Repair Notice

R1801

RH Stalk and Trailer Hand Brake Retrofit

8/16/2019

3) Compact Trailer Hand Brake Valve Replacement

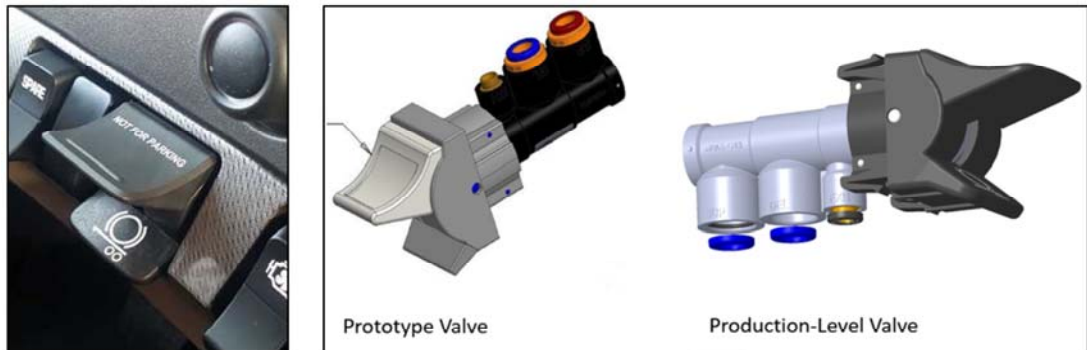
- Remove and replace the valve with the production level part.
